ADDENDUM NO. 3
February 18, 2025

DLH North Business Development Area Hangar
City Project No. 25-4401
Duluth International Airprt
Duluth, Minnesota

SEH No. DULAI 180746

1 EXTERIOR ELEVATION - WEST
A201 1/8" = 1'-0"

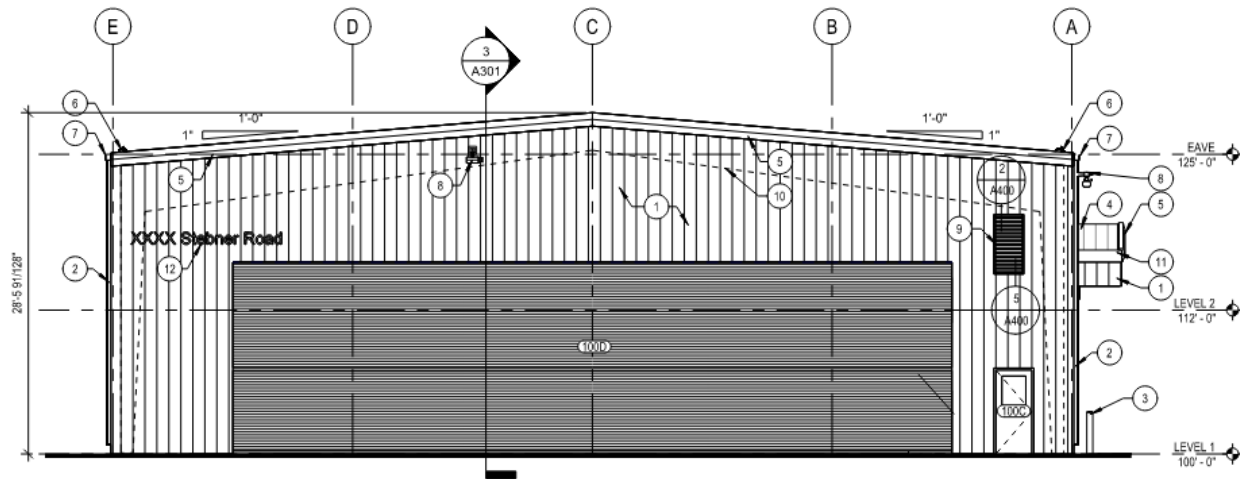
3. Drawing No. G007 Summary of Estimated Quantities, DELETE in its entirety and REPLACE with attached new Drawing No. G007.
4. Drawing No. C103 Proposed Fence Details, revise General Note 7 to say “ CHAIN LINK FABRIC SHALL BE WOVEN FROM 9 GAUGE GALVANIZED STEEL WIRE IN A 2-INCH (50 MM) MESH AND SHALL CONFORM TO THE REQUIREMNTS OF ASTM A392.”
5. Drawing No. A201 Exterior Elevations, Address signage on building in West and North Elevation should read 4615 Stebner Road.

- A. Provide the following:
 - 1. Dimensional Letters and Numbers:
 - a. 8 inches high (Two Sets):
 - 1) Signage Text:
 - a) 4615 STEBNER ROAD (verify building number and address with Owner)
 - b. Proposed lettering and message shall be approved via shop drawing review prior to fabrication.
